**Re: Additional Comments on Farm Road Homes -  
Title V Plans and Nitrate/Mounding Concerns**  
Farm Road Homes Project  
55-65 Farm Road  
Sherborn, MA

**Annotated Excerpts from  
Hydrogeologic Evaluations Report  
dated December 11, 2023**

Fig. Percolation to Permeability Comparison

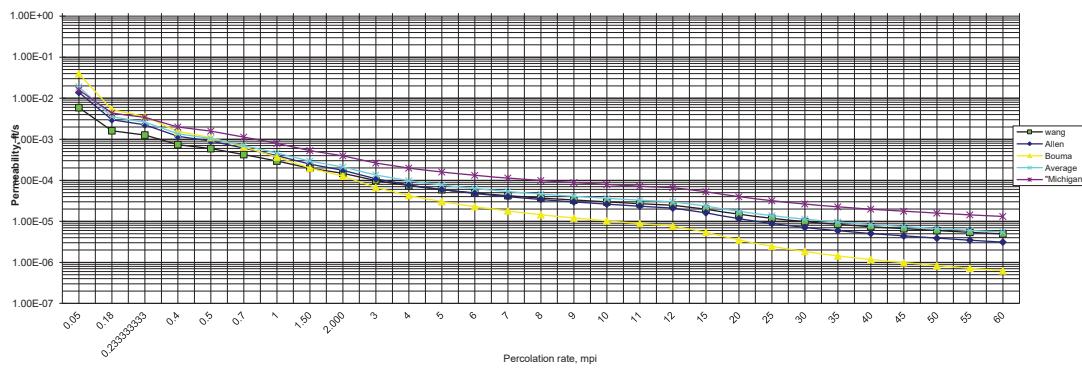
This highlighted value is the percolation rate that would need to have been achieved to use Engineer's own calculation to derive a 24 feet per day (fpd) hydraulic conductivity value - A VALUE OF 1 MPI (24 feet per day = 0.0002777 feet per second)

THESE ARE THE ACTUAL CORRECT VALUES OF 3 TO 5 MPI AND YIELD A HYDRAULIC CONDUCTIVITY VALUE OF AT LEAST AN ORDER OF MAGNITUDE LOWER THAN THAT WHICH EXISTS IN THEIR PLANS. THESE PERCOLATION RATES YIELD A CONSERVATIVE HYDRAULIC CONDUCTIVITY VALUE ESTIMATE OF 2.6 FEET PER DAY - TEN TIMES LOWER THAN USED IN THE DESIGN DOCUMENTS.

THESE ARE THE HYDRAULIC CONDUCTIVITY VALUES THAT WERE USED IN THEIR DESIGN DERIVED FROM PERCOLATION RATES BETWEEN 1 AND 2 MINUTES PER INCH (MPI).

Using 5 mpi, the conservative conversion yields a K value or 0.0000302 feet per second.
